UNITED STATES PATENT AND TRADEMARK OFFICE

APPLICATION NO.	FILING DATE	FIRST NAMED INVENTOR	ATTORNEY DOCKET NO.	CONFIRMATION NO.
10/666,074	09/18/2003	Roger P. Jackson	10,250	7659

Office Action Summary	Application No.	Applicant(s)	
	10/666,074	JACKSON, ROGER P.	
	Examiner	Art Unit	
	Anu Ramana	3733

DETAILED ACTION

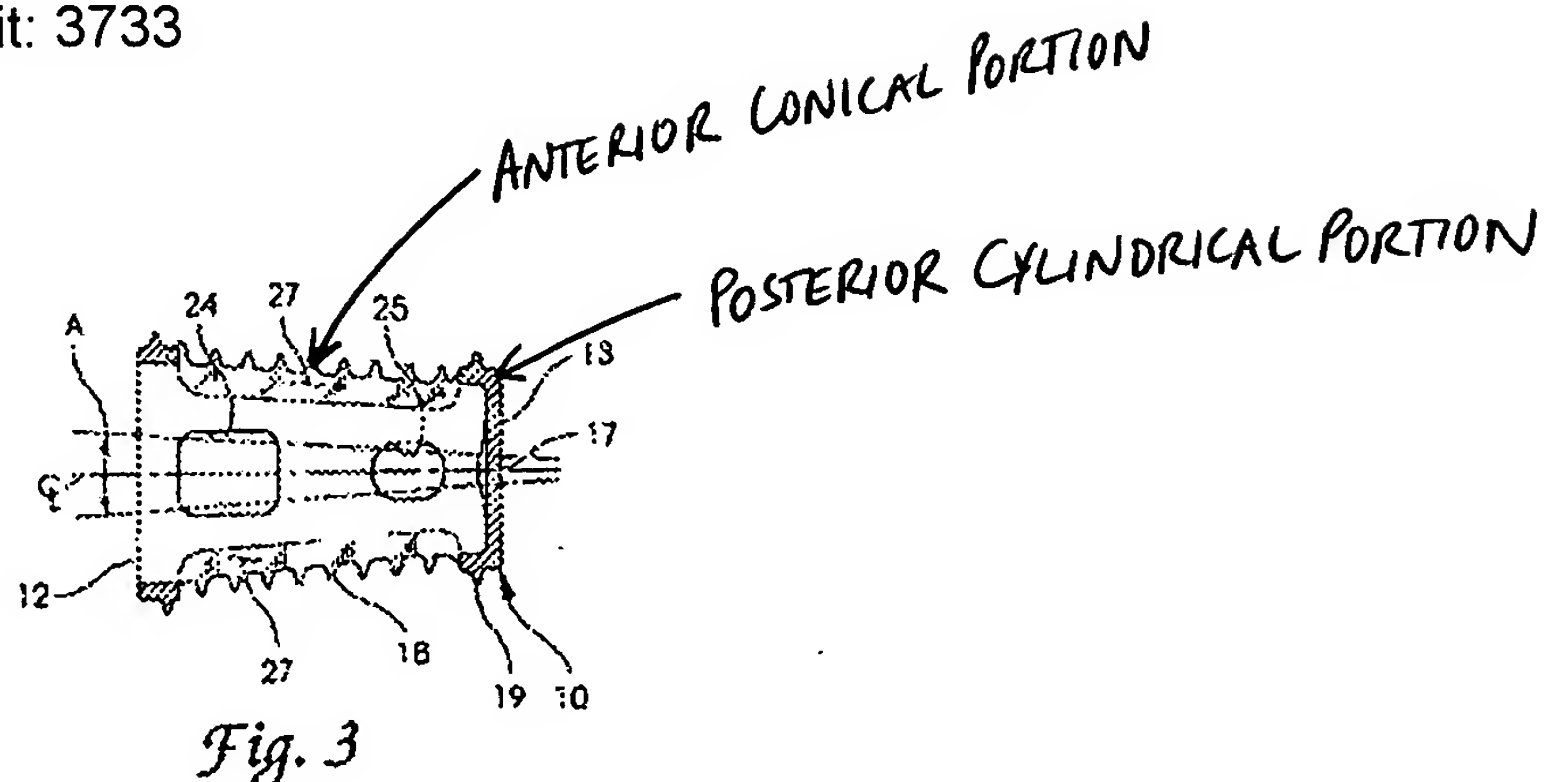
Zdeblick et al. disclose an interbody fusion device including an anterior conical portion, a posterior cylindrical portion joined to the anterior conical portion at the converged end of the conical portion and partial thread members extending radially outward from the conical and cylindrical portions (Figs. 3, 8A and 14(d), col. 5, lines 41-59 and col. 12, lines 21-34). See marked up Fig. 3 from Zdeblick et al. on the following page.

Zdeblick et al. disclose all elements of the claimed invention except for anterior threads extending outwardly from the anterior conical portion for at least two revolutions and posterior threads extending outwardly from the posterior surface for at least two revolutions.

At the time the invention was made, it would have been a matter of obvious design choice to a person of ordinary skill in the art to provide anterior and posterior threads extending for at least two revolutions because Applicant has not disclosed that providing at least two revolutions of anterior and posterior threads provides an advantage, is used for a particular purpose, or solves a stated problem. It would have been prima facie obvious to modify Zdeblick et al. to obtain the invention specified in claims 1, 9, 16, 26 and 28 because such a modification would have been considered a mere design consideration which fails to patentably distinguish over the prior art of Zdeblick et al.
